SUBJECT: Operation Procedures for the transmission of fax messages  
while making memory copies.

AD-1

SUBJECT: ROM History (AD1-FAX option)

We inform you of the firmware history for the AD1-Fax option.  
(For the USA Model)

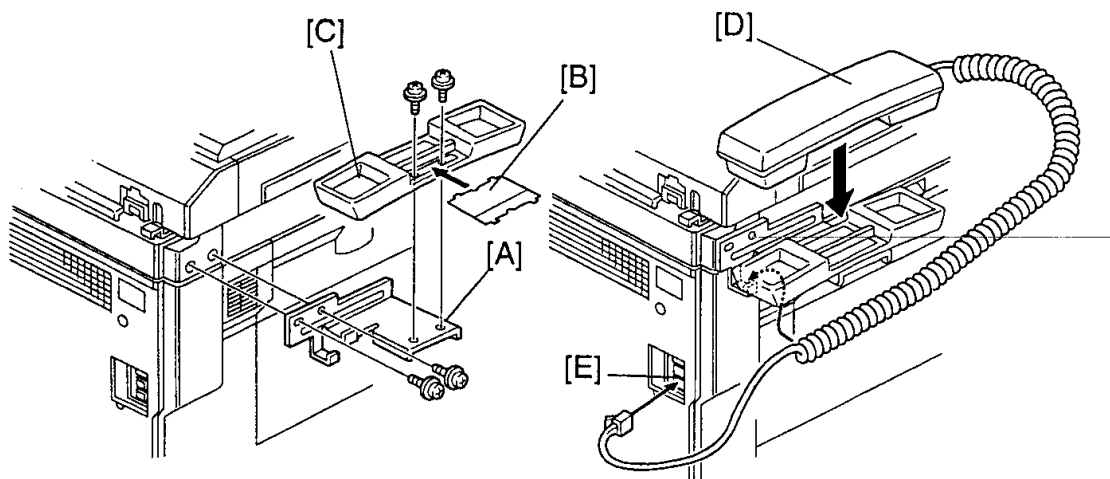
In some countries, the optional handset is available for the Aficio 200. To install the optional handset, use the bracket which is included in the Fax Unit Option, Type 250. Also, correct the installation procedure in the Service Manual on page 3-12 as follows.

1. Install the bracket [A] ( 2 screws ), as shown.

\* The bracket [A] in the carton box of the Fax Unit Option Type 250 must be used.

2. Remove the label [B] from the handset cradle [C]. Install the cradle on the bracket [A] ( 2 screws ), then replace the label [B].

3. Install the handset [D] as shown. Connect the handset cord to the " TEL " jack [E] on the machine.
